TOWN OF PLAINFIELD PLAN COMMISSION REPORT

CASE NO.: PUD-19-101

REQUESTED ACTIONS: Planned Unit Development Zone Map Change and Final Detailed Plan

LOCATION: 311 Retention Lane

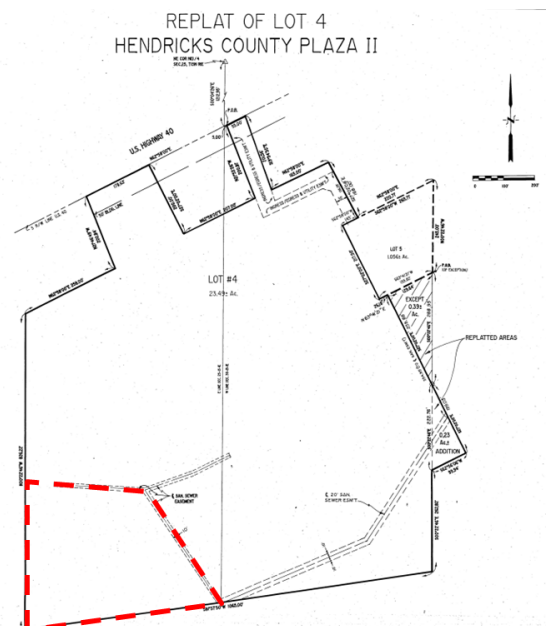
Transportation: The site is designed with 2 access drives to a Private Street named Retention Lane. A single drive with a divided entry is designed to provide access to the parking lot adjacent to the building. A second drive is for a separated parking lot serving the site.

Retention Lane does not have direct access to a public street, but abuts a property with the same ownership, that does have direct access to Main St. The petitioner will need to ensure an access easement exists or is created as part of this development.
